## ***ROC MEETING AGENDA***

**Technical Committee on Smoke Management Systems  
NFPA 92, 92A, 92B and 204 ROC MEETING  
November 16-17, 2010  
The Luxor Hotel/Casino  
3900 Las Vegas Boulevard South  
Las Vegas, Nevada 89110**

**A.11.4.1.** Figure A.11.4.1 shows the recommended spacing of sprinklers with respect to the draft curtain locations.

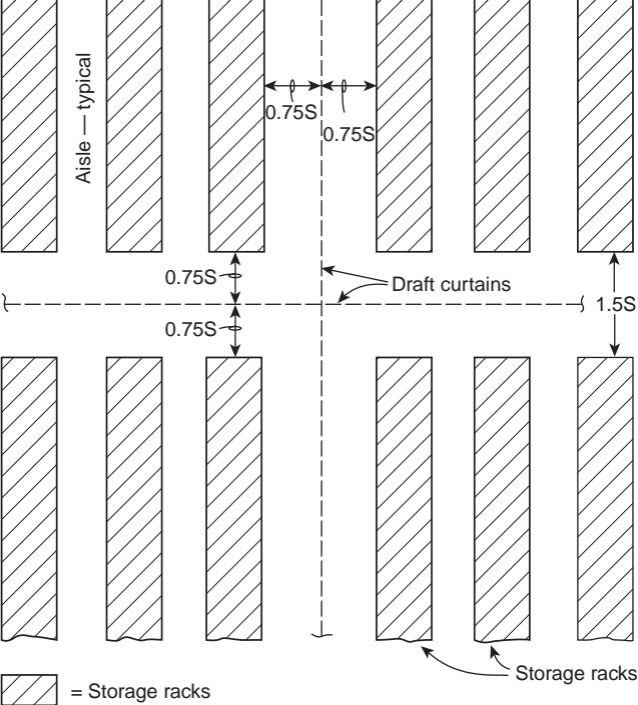
**11.4.1\* Draft curtains provided in storage areas** shall be placed at the longitudinal center of an aisle space. The aisle space shall not be less than 1.5 times the spacing of ceiling sprinklers in the direction perpendicular to the draft curtain. Sprinklers shall be located on both sides of the curtain per NFPA 13 requirements for sprinkler placement with respect to walls. If a full-height partition is used in lieu of a draft curtain, normal aisle spacing shall be permitted.

Figure 11.2.2.3.3 (Source: FM Data Sheets)

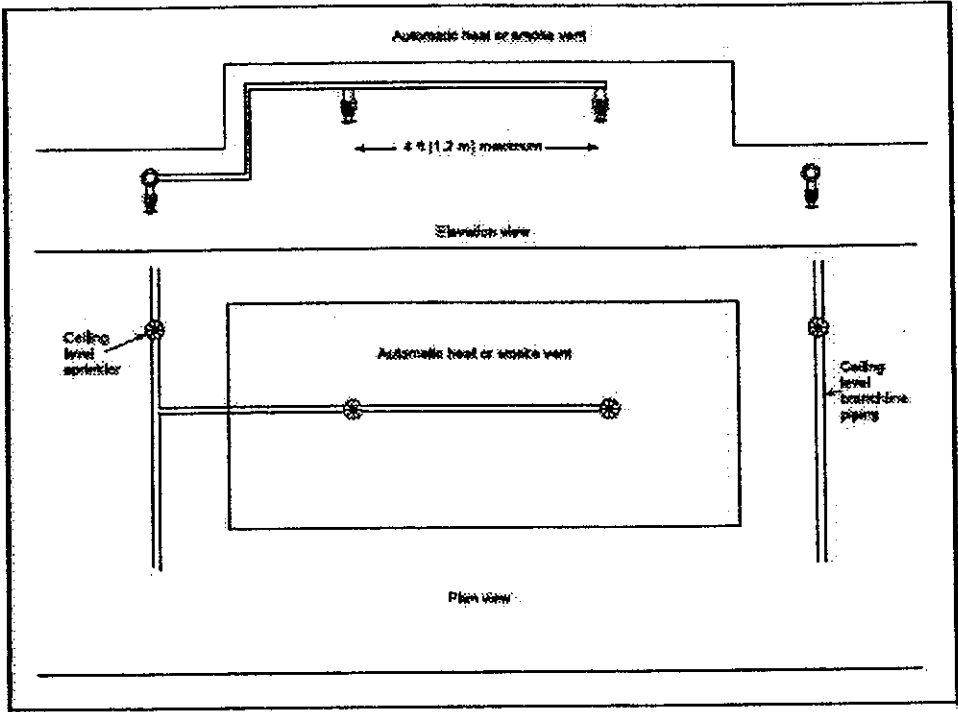
11.2.2.3.3 Install quick-response sprinklers directly under the vent opening on a maximum 4 ft. (1.2m) linear and 16 ft<sup>2</sup> (1.5 m<sup>2</sup>) area spacing. [See Figure 11.2.2.3.3 for a diagram of this arrangement.] Ensure these sprinklers have, at a minimum, the same K-factor and orientation as the adjacent ceiling-level sprinklers and are fed by sprinkler piping no smaller than the ceiling level branchlines. Sprinklers located under the ceiling vent and installed as outlined above do not need to be added to the hydraulic design of the ceiling sprinkler system; or

Example: Sprinkler spacing is 10 ft (3 m) in both directions.  
 Minimum spacing between face of storage and draft curtain is 7.5 ft (2.3 m) so minimum aisle space at draft curtain > 15 ft (4.6 m).
